PMOC REPORT

OP 32A – Project Transit Capacity Review
OP 32C – Project Scope Review
OP 32D – Project Delivery Method Review
OP 33 – Capital Cost Estimate Review
OP 34 – Project Schedule Review
OP 40 – Risk and Contingency Review

Honolulu High-Capacity Transit Corridor Project City and County of Honolulu Honolulu, HI

October 2011 (FINAL)

Figure 6. Peak Capacity Specifications and Peak Demand Forecasts
with Peak 15 Minute Rate shown

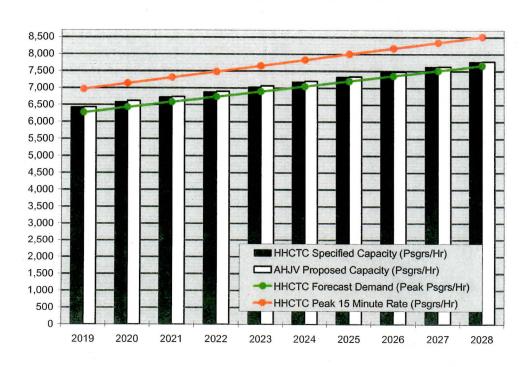
Figure 6 illustrates the gap between average hourly peak flows and the ridership that would be expected if passengers arrived at a rate 3% higher than the typical peak hour forecast during any rush hour period.

The overall effect of this approach is forecast to adversely affect the comfort of some peak passengers, but, since the desired level of crowding set by grantee is relatively generous, the system should still be able to physically carry all forecast passengers in each year of forecast operation.

Figure 8. Forecast Passenger Loads and Capacity (2028)

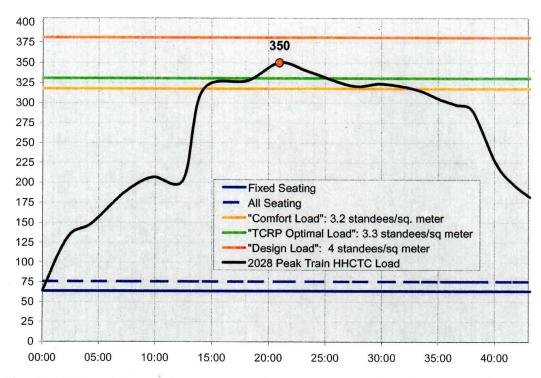
Figure 8 shows how the typical peak train would be likely to load in 2028 if AHJV found an acceptable way to operate peak service more frequently than the minimum operating headway. Since the proposed peak headway is reduced by 17% between 2019 and 2028 while the forecast peak ridership increases by 22% over the same period, the magnitude and extent of crowding is forecast to increase slightly over the life of the contract.

Should AHJV and the grantee agree on a plan to operate service at frequencies that exceed the minimum operating headway, the peak train in the last year will carry a maximum load of 350 passengers. Peak passengers on eastbound trains moving between the Pearl Ridge and Kalihi would be on trains exceeding the "Comfort" standard of crowding for up to 15 minutes. It is estimated that 2,368 passengers would ride on "overcrowded" peak trains. This would still constitute only 4% of the total forecast weekday ridership²⁵ but 23% of all eastbound peak hour passengers.

Figure 15. Thousands of Infrastructure Maintenance Hours per Route Mile

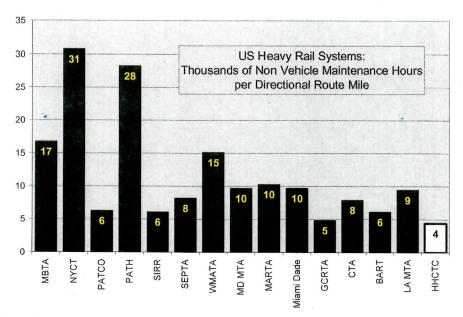
Figure 15 illustrates how AHJV's infrastructure staffing plans call for it to be the most parsimonious of all US rapid transit operations. This may be unrealistic in the long run,

especially in light of the system's high reliance on precision automation tools to replace operating manpower.

The PMOC suggests that the grantee may wish to review infrastructure maintenance staffing assumptions with AHJV to ensure that expectations are realistically aligned with service availability and customer service goals.

Figure 16. Thousands of Infrastructure Maintenance Hours per Track Mile

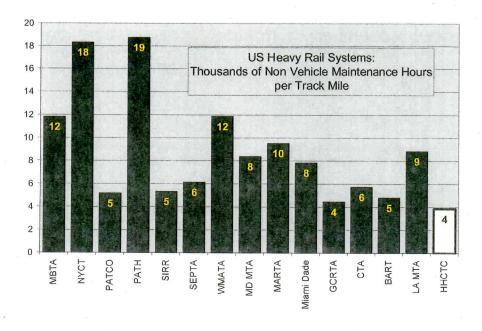
Figure 16 reinforces the suspicion that AHJV and the grantee may be underestimating the maintenance workload required to sustain the system infrastructure and operation.

Figure 28. Calendar Library

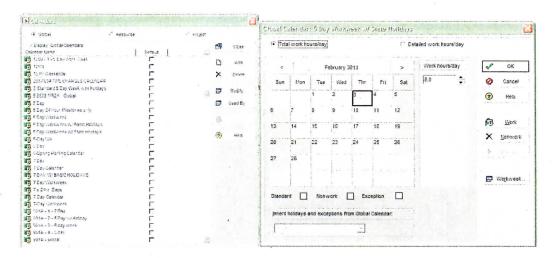
The calendar library does not contain anticipated inclement weather days. These periods of non-work performance can be addressed in many ways, such as by increasing activity durations or accounting for them in separate calendars. The grantee did state that it incorporated latent contingency into the activity original durations, but not the calendars, to account for inclement weather. The grantee also stated that Hawaii, in general, does not encounter a significant amount of severe weather or undergo significant seasonal conditions that would negatively impact construction work activity.

Figure 35. Project Duration Cruciality with Risk Impacts

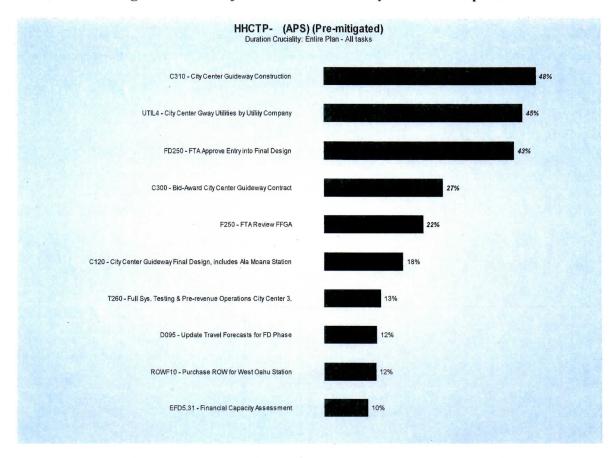
The figure below illustrates the top schedule activities containing the highest amount of duration cruciality for the project as a whole. Duration cruciality is a better indicator than duration sensitivity because it distinguishes only the sensitive activities which also contain the highest criticality index. The higher the duration cruciality percentage the

greater the likelihood the activity will affect the critical path and the project completion date. Note none of the risk events in the current model are represented in this group.

The grantee should concentrate on the activities contained in the duration cruciality tornado diagram and related critical path items during risk mitigation and monitoring.
